PRODUCT/PROCESS CHANGE NOTICE (PCN)

PCN #: A1401-01 Product Affected: 5.0mm x 7.0mm CDIP-10 Date Effective: 7-Jun-2014	DATE: 7-Mar-2014	MEANS OF DISTINGUISHING CHANGED DEVICES: <input checked="" type="checkbox"/> Product Mark <input type="checkbox"/> Back Mark Change in capacitor is traceable through assembly lot code. <input type="checkbox"/> Date Code <input type="checkbox"/> Other
---	-------------------------	---

ATTACHMENT I - PCN # : A1401-01

PCN Type: Alternate Capacitor
Data Sheet Change: None
No change in moisture sensitivity level (MSL)

Detail Of Change:

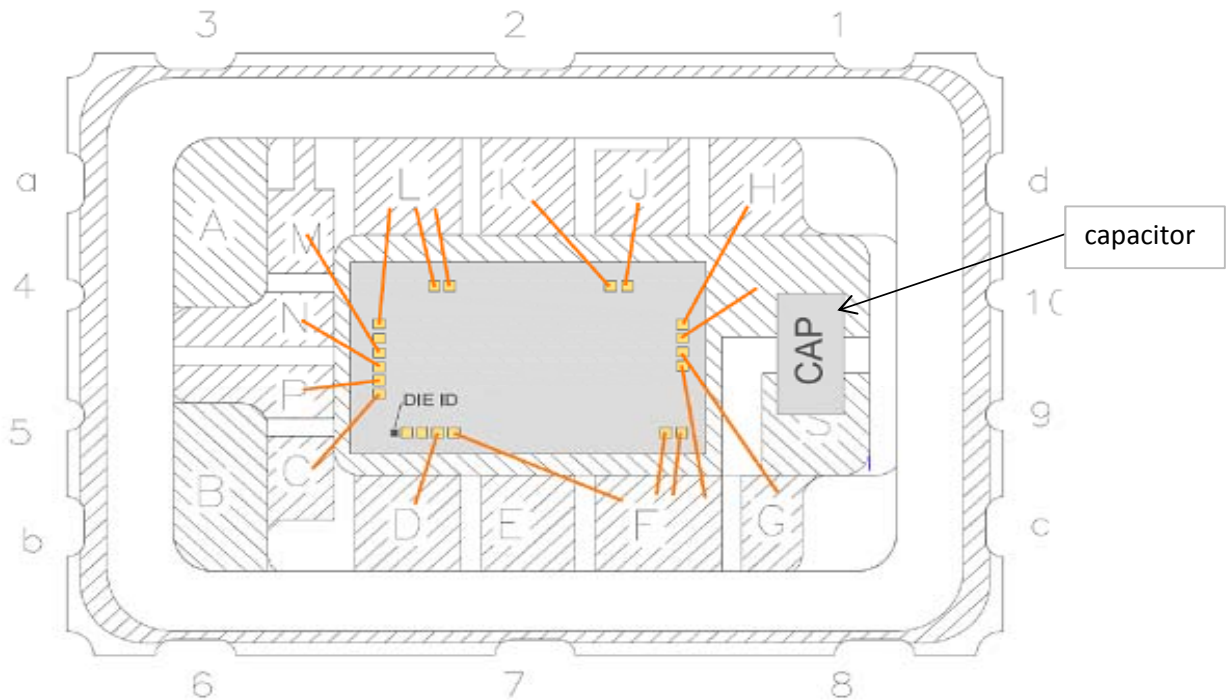
This notification is to advise our customers that IDT has qualified an alternate capacitor used internal to the package of 5.0mm x 7.0mm CDIP-10. Refer to below illustration.

This alternate capacitor was designed with these key features:

1. End cap shape to optimize mounting with conductive cement.
2. Reduce the use of gold.
3. Exceptionally high reliability for the auto industry application.

Description	Existing Capacitor	Alternate Capacitor
Supplier Name	Venkel Ltd	Murata Manufacturing Co. Ltd
Capacitor Part# (Supplier part#)	C0402X7R160-104KGP	GCG155R71C104KA01D (10K reel) GCG155R71C104KA01J (50K reel)
Capacitor Part# (IDT part#)	50-161-161	50-205-205
Size	0402	0402
Dielectric Material	X7R	X7R
Capacitance	0.1uF ± 10%	0.1uF ± 10%
Voltage (VDC)	16	16
End Caps Plating	Au/Ni/Cu	Pd/Ag/Cu
Temperature Range	-55 °C to 125 °C	-55 °C to 125 °C
T&R	Paper Tape	Not Known
